MEQI-50 Series and Accessories LC

Design Change Notification

MEQI-50 Series

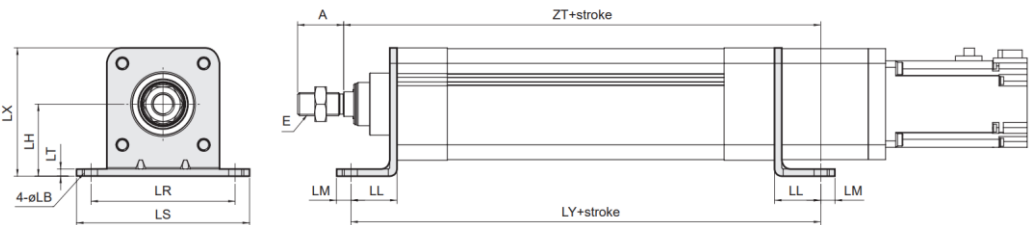
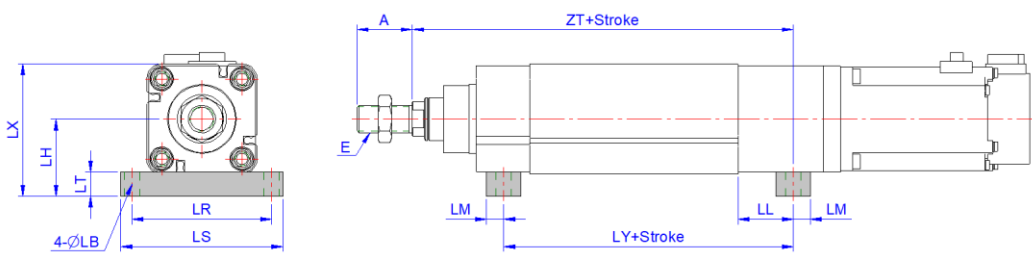
Before	<p>BC Motor direct connection</p>																																																																	
	<table border="1"> <thead> <tr> <th>Code</th> <th>A</th> <th>B1</th> <th>B2</th> <th>C</th> <th>E</th> <th>G</th> <th>H</th> <th>I</th> <th>J</th> <th>K</th> <th>L1</th> <th>L2</th> <th>O</th> <th>R</th> <th>S</th> <th>X</th> <th>ZB</th> <th colspan="2">ZC</th> <th colspan="2">ZT</th> </tr> <tr> <th>Size</th> <th></th> <th></th> <th></th> <th></th> <th></th> <th></th> <th></th> <th></th> <th></th> <th></th> <th></th> <th></th> <th></th> <th></th> <th></th> <th></th> <th></th> <th>servo</th> <th>step</th> <th>servo</th> <th>step</th> </tr> </thead> <tbody> <tr> <td>50</td> <td>32</td> <td>17</td> <td>24</td> <td>37</td> <td>M16×1.5</td> <td>25</td> <td>40</td> <td>19</td> <td>4</td> <td>31</td> <td>4.5</td> <td>18</td> <td>46.5</td> <td>8</td> <td>M8×1.25</td> <td>65</td> <td>152</td> <td>67</td> <td>48</td> <td>256</td> <td>239</td> </tr> </tbody> </table>	Code	A	B1	B2	C	E	G	H	I	J	K	L1	L2	O	R	S	X	ZB	ZC		ZT		Size																		servo	step	servo	step	50	32	17	24	37	M16×1.5	25	40	19	4	31	4.5	18	46.5	8	M8×1.25	65	152	67	48	256

Code	A	B1	B2	C	E	G	H	I	J	K	L1	L2	O	R	S	X	ZB	ZC		ZT																																														
Size																		servo	step	servo	step																																													
50	32	17	24	37	M16×1.5	25	40	19	4	31	4.5	18	46.5	8	M8×1.25	65	152	67	48	256	239																																													
After	<p>BC Motor direct connection</p>																																																																	
	<table border="1"> <thead> <tr> <th>Code</th> <th>A</th> <th>B1</th> <th>B2</th> <th>C</th> <th>E</th> <th>G</th> <th>H</th> <th>I</th> <th>J</th> <th>K</th> <th>L1</th> <th>L2</th> <th>O</th> <th>R</th> <th>S</th> <th>X</th> <th>ZB</th> <th>ZC</th> <th>ZT</th> </tr> </thead> <tbody> <tr> <td>50</td> <td>32</td> <td>17</td> <td>24</td> <td>37</td> <td>M16×1.5</td> <td>25</td> <td>40</td> <td>19</td> <td>4</td> <td>31</td> <td>4.5</td> <td>18</td> <td>46.5</td> <td>8</td> <td>M8×1.25</td> <td>64</td> <td>152</td> <td>59.5</td> <td>248.5</td> </tr> </tbody> </table>	Code	A	B1	B2	C	E	G	H	I	J	K	L1	L2	O	R	S	X	ZB	ZC	ZT	50	32	17	24	37	M16×1.5	25	40	19	4	31	4.5	18	46.5	8	M8×1.25	64	152	59.5	248.5

Code	A	B1	B2	C	E	G	H	I	J	K	L1	L2	O	R	S	X	ZB	ZC	ZT																																															
50	32	17	24	37	M16×1.5	25	40	19	4	31	4.5	18	46.5	8	M8×1.25	64	152	59.5	248.5

Before	<p>LC * Only for (BC) motor direct connection type.</p>  <table border="1" data-bbox="510 795 1077 862"> <thead> <tr> <th>Code Size</th> <th>A</th> <th>E</th> <th>LB</th> <th>LH</th> <th>LL</th> <th>LM</th> <th>LR</th> <th>LS</th> <th>LT</th> <th>LX</th> <th>LY</th> <th>ZT</th> </tr> </thead> <tbody> <tr> <td>50</td> <td>32</td> <td>M16×1.5</td> <td>9</td> <td>45</td> <td>32</td> <td>10</td> <td>90</td> <td>110</td> <td>5</td> <td>77.5</td> <td>216</td> <td>221</td> </tr> </tbody> </table>	Code Size	A	E	LB	LH	LL	LM	LR	LS	LT	LX	LY	ZT	50	32	M16×1.5	9	45	32	10	90	110	5	77.5	216	221
	Code Size	A	E	LB	LH	LL	LM	LR	LS	LT	LX	LY	ZT														
50	32	M16×1.5	9	45	32	10	90	110	5	77.5	216	221															
After	<p>LC * Only for (BC) motor direct connection type.</p>  <table border="1" data-bbox="510 1355 1077 1422"> <thead> <tr> <th>Code Size</th> <th>A</th> <th>E</th> <th>LB</th> <th>LH</th> <th>LL</th> <th>LM</th> <th>LR</th> <th>LS</th> <th>LT</th> <th>LX</th> <th>LY</th> <th>ZT</th> </tr> </thead> <tbody> <tr> <td>50</td> <td>32</td> <td>M16×1.5</td> <td>9</td> <td>45</td> <td>32</td> <td>10</td> <td>81</td> <td>94</td> <td>14</td> <td>77</td> <td>168</td> <td>221</td> </tr> </tbody> </table>	Code Size	A	E	LB	LH	LL	LM	LR	LS	LT	LX	LY	ZT	50	32	M16×1.5	9	45	32	10	81	94	14	77	168	221

Code Size	A	E	LB	LH	LL	LM	LR	LS	LT	LX	LY	ZT														
50	32	M16×1.5	9	45	32	10	81	94	14	77	168	221

- It will not affect the usage of finished product, and will replace sequentially.
- Accessories **LC** will be replaced from Oct. , 2023.
